CNL-17-070

Clinch River Nuclear Site
NRC Docket No. 52-047

Subject: Submittal of Supplemental Information Associated with Hydrologic Engineering in Support of the Clinch River Nuclear Site Early Site Permit Application

Supplemental Information Regarding Site Safety Analysis Report Section 2.4, "Hydrologic Engineering"

Figure 2.4.3-17. Unit Hydrographs, Sub-basins 1-6 (Sheet 1 of 8)

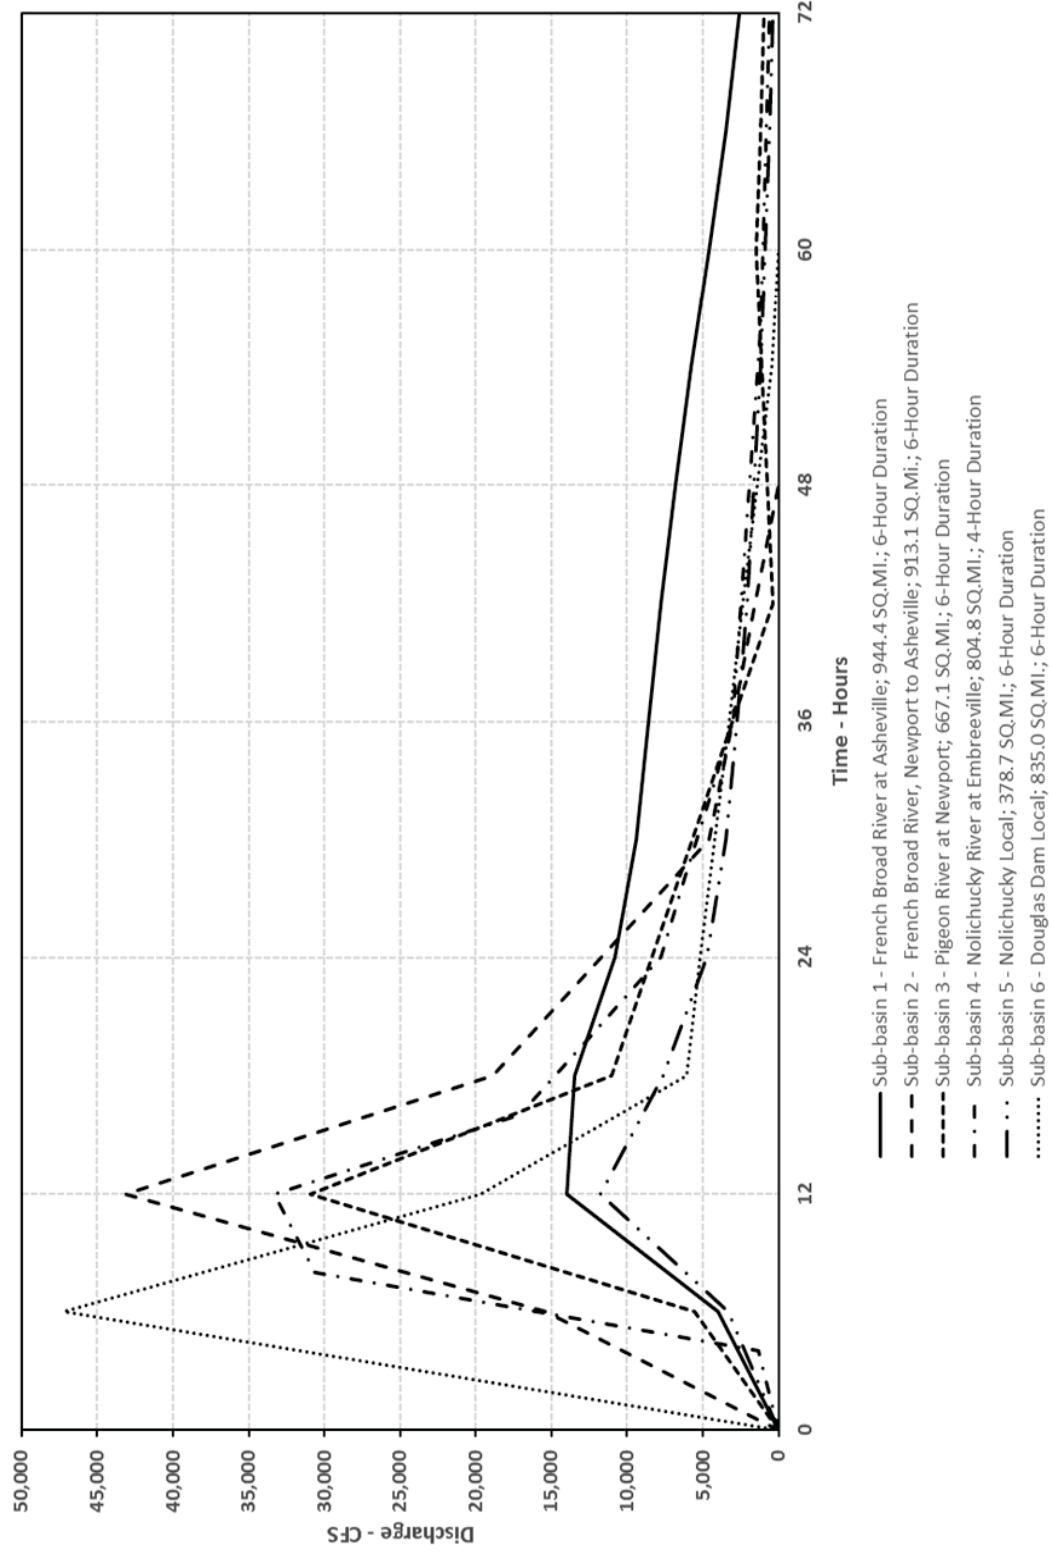
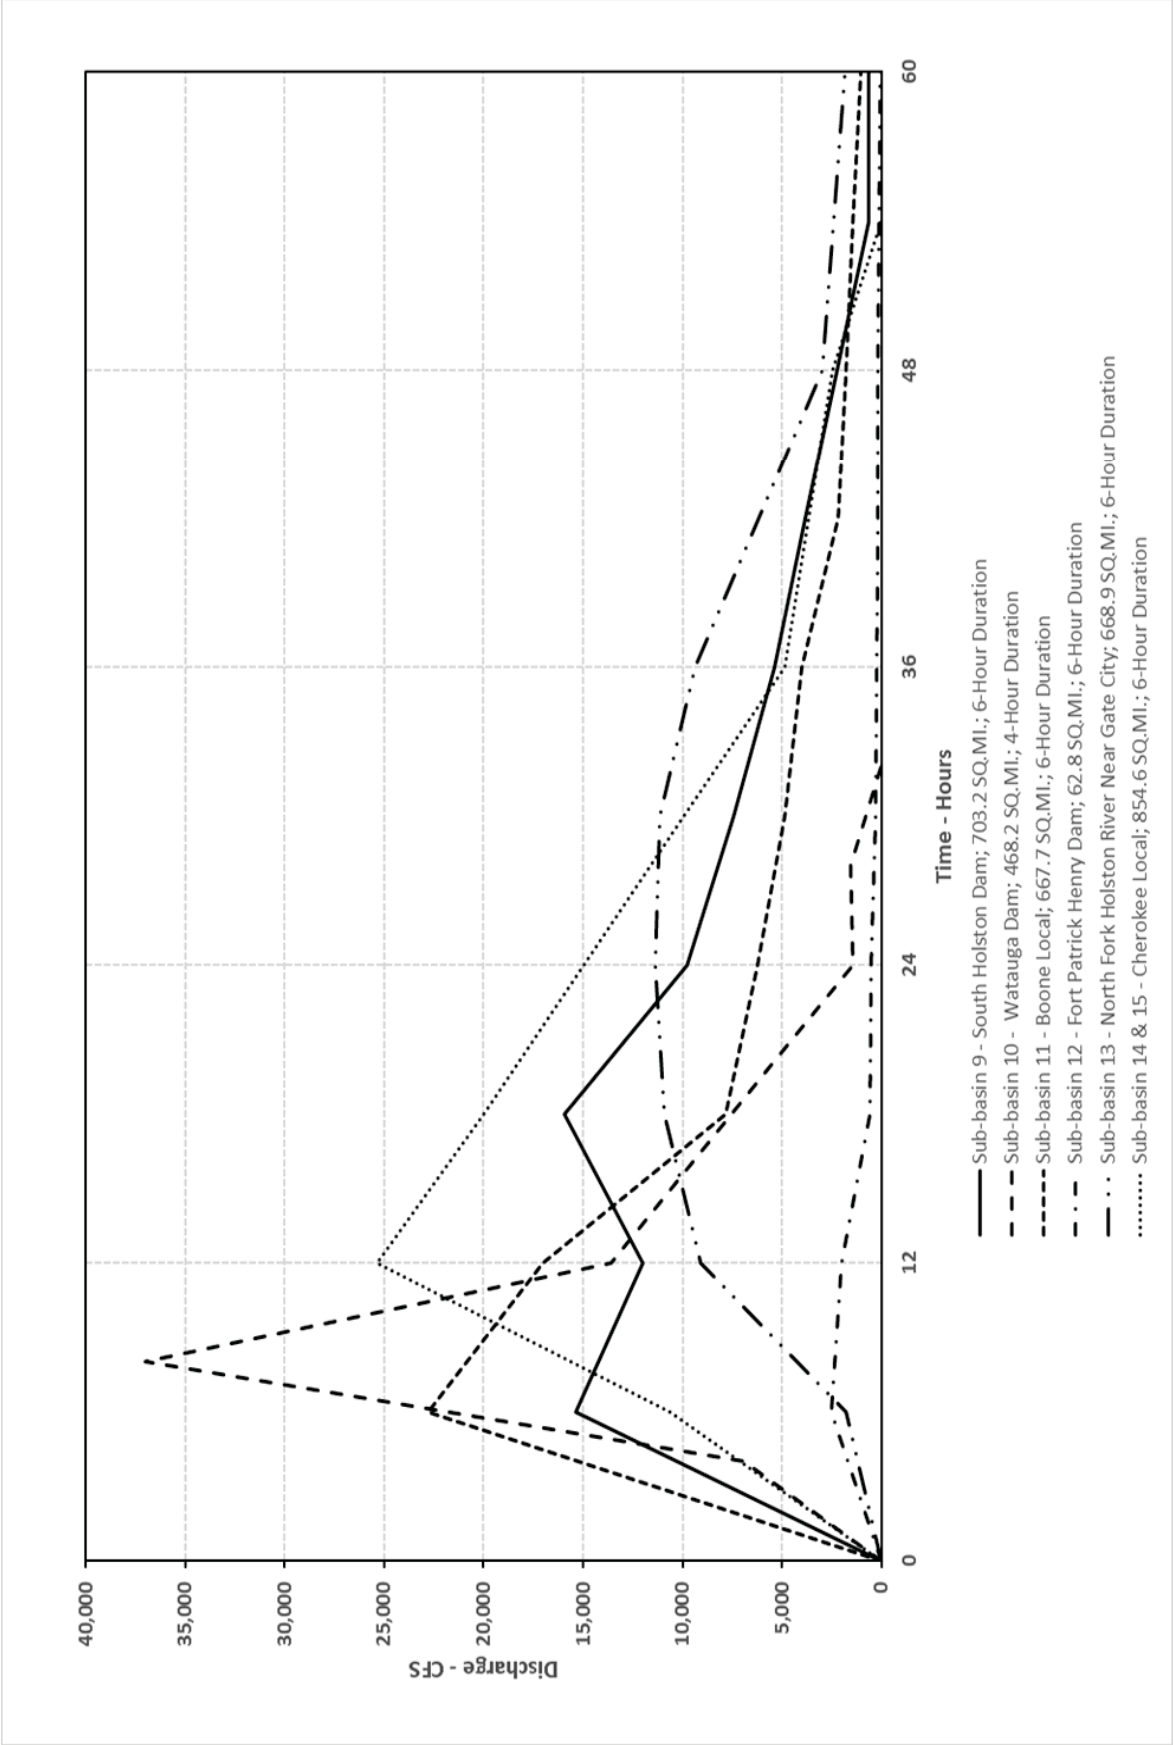
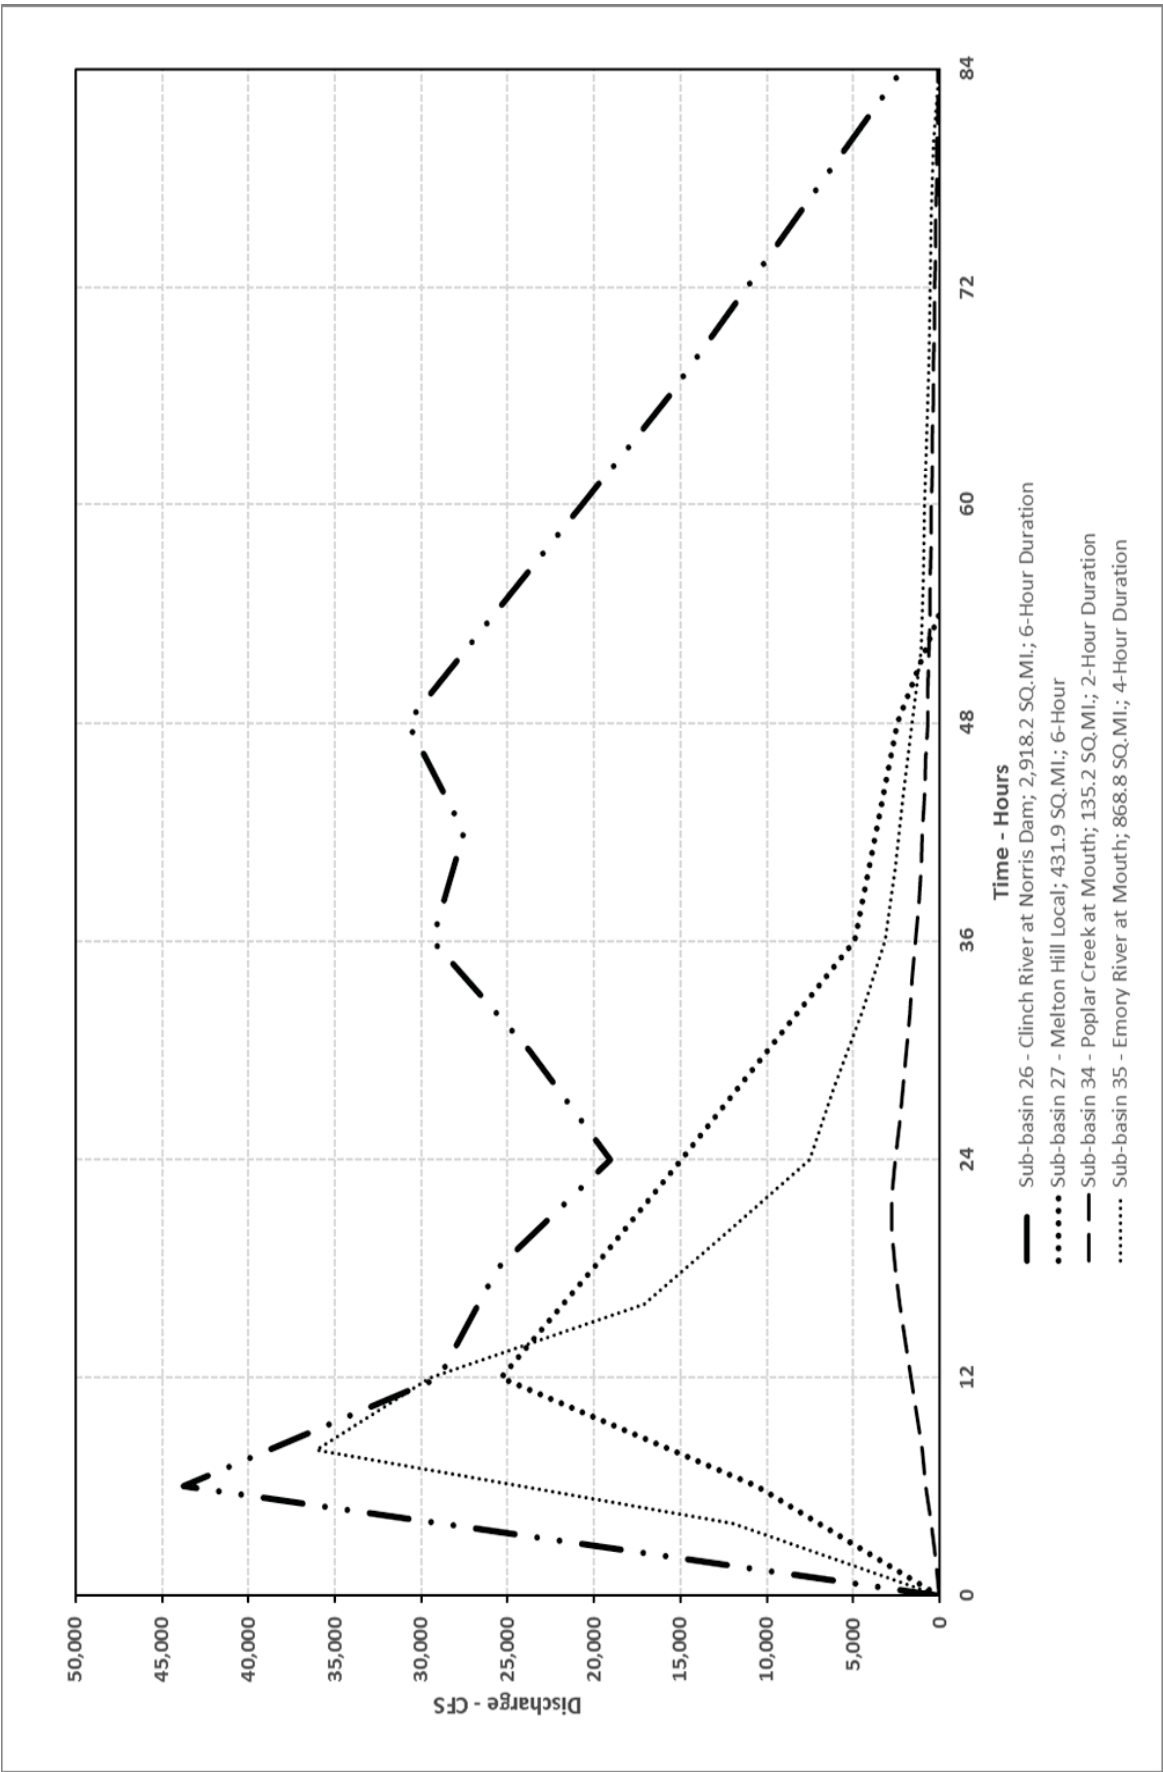
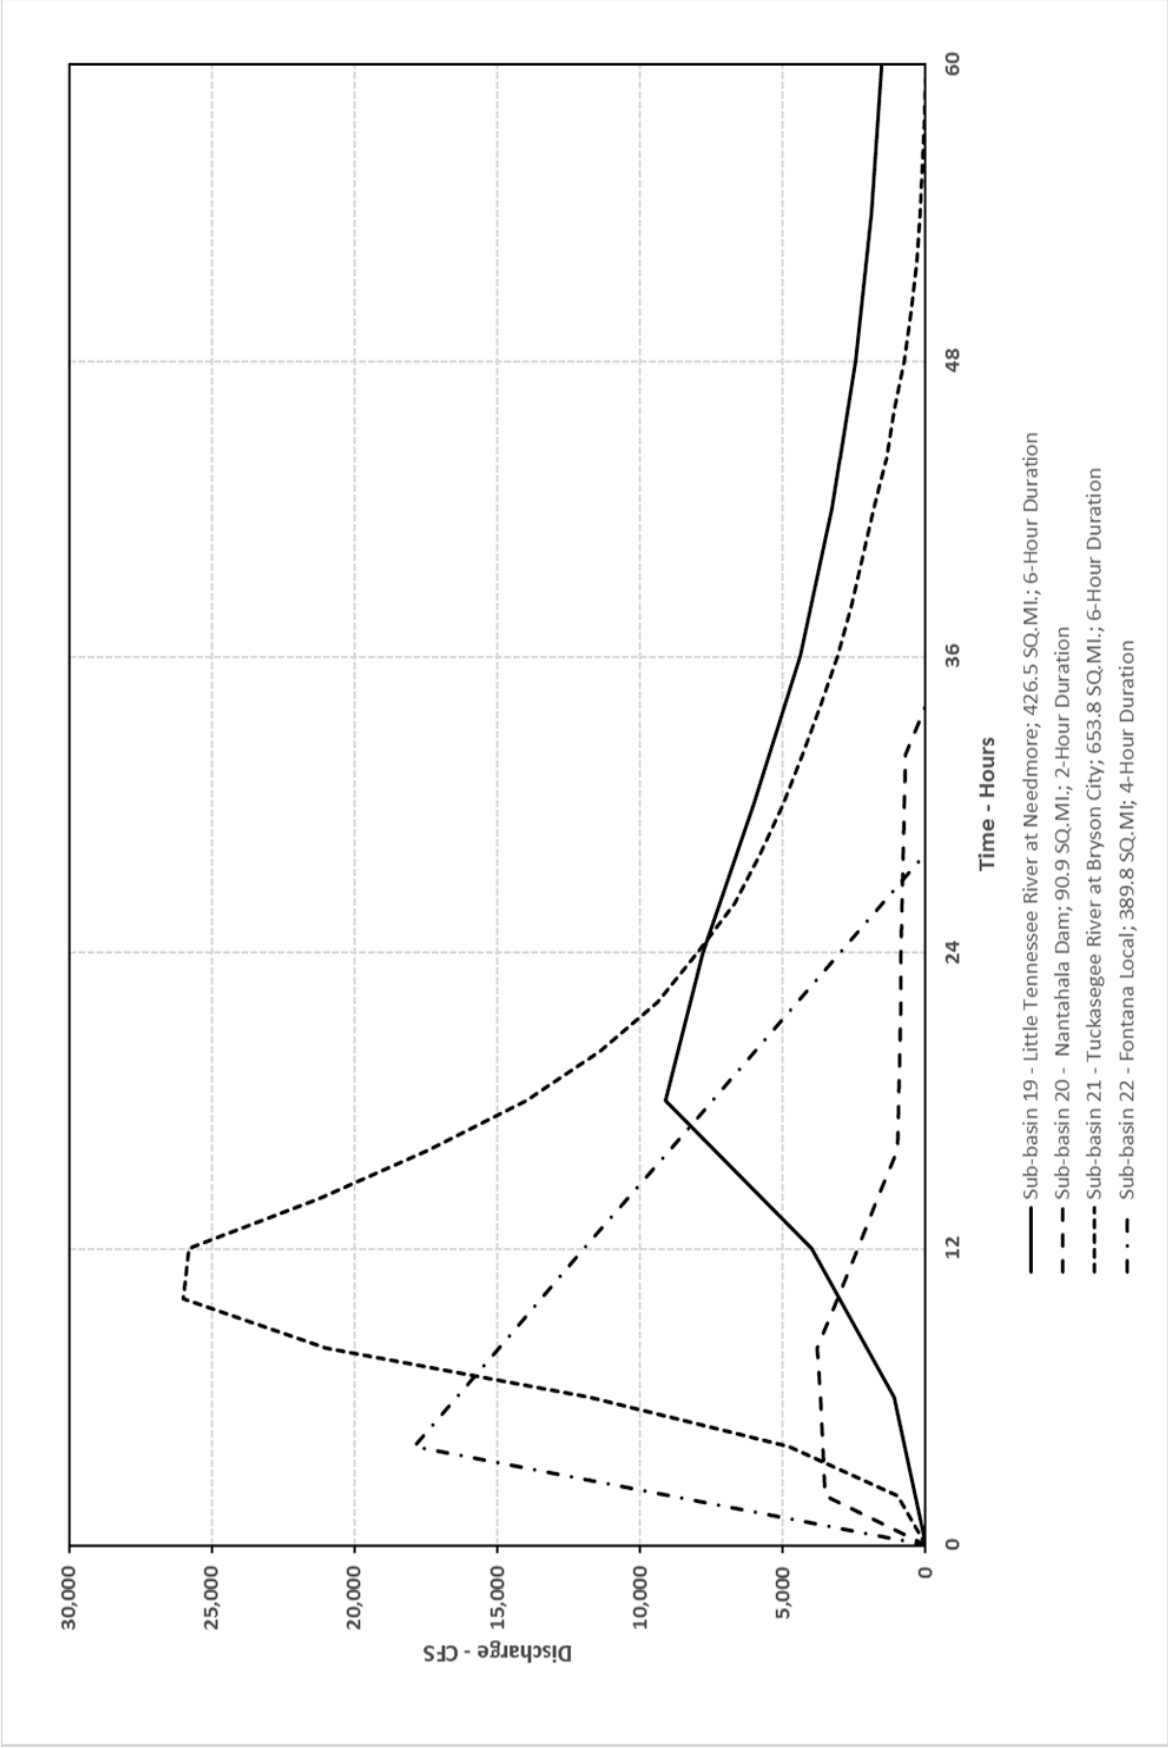
A discussion of how the Unit Hydrographs (UHs) were developed, including validation of the UH's is being added, under a subheading titled "Unit Hydrograph Development and Validation," to SSAR Subsection 2.4.3.4.1, "Runoff Model." Validated unit hydrograph figures and reference to those figures are also being added with this revision. In addition, a discussion of how the inflows were determined for the 1973/2003 storms used in the calibration is being added to SSAR Subsection 2.4.3.4.3, "Stream Course Model Geometry Development and Calibration." For these changes, see the markup provided in SSAR Subsection 2.4.3.4.1, subheading "Unit Hydrograph Development and Validation," addition of new Figures 2.4.3-17, Sheets 1 through 8, and Figures 2.4.3-18, 2.4.3-19, and 2.4.3-20, and SSAR Subsection 2.4.3.4.3, the eighth paragraph, in Attachment 3.
